APPLICATION NO.	FILING DATE	FIRST NAMED INVENTOR	ATTORNEY DOCKET NO.	CONFIRMATION NO.
10/791,484	03/02/2004	Giancarlo Cassarino	930026-2017	1887
20999 7	7590 06/09/2005		EXAMINER	
FROMMER LAWRENCE & HAUG			WELCH, GARY L	
745 FIFTH AVENUE- 10TH FL. NEW YORK, NY 10151			ART UNIT	PAPER NUMBER
•			3765	
			DATE MAILED: 06/09/2003	5

578			
	Application No.	Applicant(s)			
Office Action Summany	10/791,484	CASSARINO, GIANCARLO			
Office Action Summary	Examiner	Art Unit			
The MAILING DATE of this communication opposite	Gary L. Welch	3765			
The MAILING DATE of this communication app Period for Reply	ears on the cover sheet with the o	correspondence address			
A SHORTENED STATUTORY PERIOD FOR REPLY THE MAILING DATE OF THIS COMMUNICATION. - Extensions of time may be available under the provisions of 37 CFR 1.13 after SIX (6) MONTHS from the mailing date of this communication. - If the period for reply specified above is less than thirty (30) days, a reply - If NO period for reply is specified above, the maximum statutory period w - Failure to reply within the set or extended period for reply will, by statute, Any reply received by the Office later than three months after the mailing earned

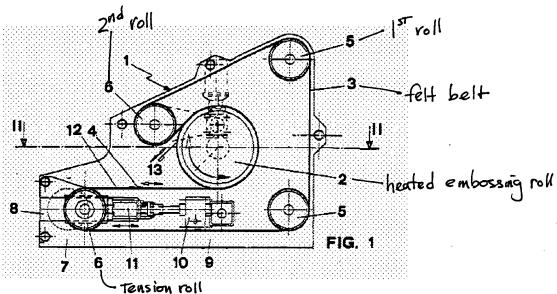
Bergozza discloses an apparatus for use in a leather industry for embossing leather textiles. The apparatus has first and second rolls, a heated embossing roll 2 operable to have the leather textile 4 wrapped around at least a portion thereof, a tension roll and a felt belt 3 operable to be wrapped around at least a portion of the tension roll and the first and second rolls and over the leather textile wrapped around the embossing roll. The apparatus is operable to enable the leather textile 4 to be conveyed around the embossing roll between the felt belt and the embossing roll so as to be embossed (see figure below).

However, Bergozza does not disclose that the felt belt is under tension in the range of 10-500 N/mm.

A review of the applicant's disclosure does not reveal any criticality for this claimed limitation (i.e., why 10-500 N/mm is better than any other value).

Therefore, it would have been obvious through routine experimentation to determine the optimum value(s) in tensioning the felt belt 3 so as to ensure successful embossing of the leather (Col. 3, lines 22-26).

With regard to claim 2, the first and second rolls, the tension roll and the embossing roll 2 are arranged so as to not to form a nip between any two rolls. With regard to claim 3, each of the first and second rolls, the embossing roll 2 and the tension roll are cylindrical in shape.

With regard to claims 4 and 9, the felt belt 3 has a high thermal, chemical and mechanical resistance and is permeable to fluid (Col. 3, lines 52-54). The claim language does not define what the applicant considers as high thermal, chemical and mechanical resistance. Additionally, it is reasonable to believe that the

With regard to claims 5 and 10, the embossing roll 2 and the felt belt 3 is a texturing medium.
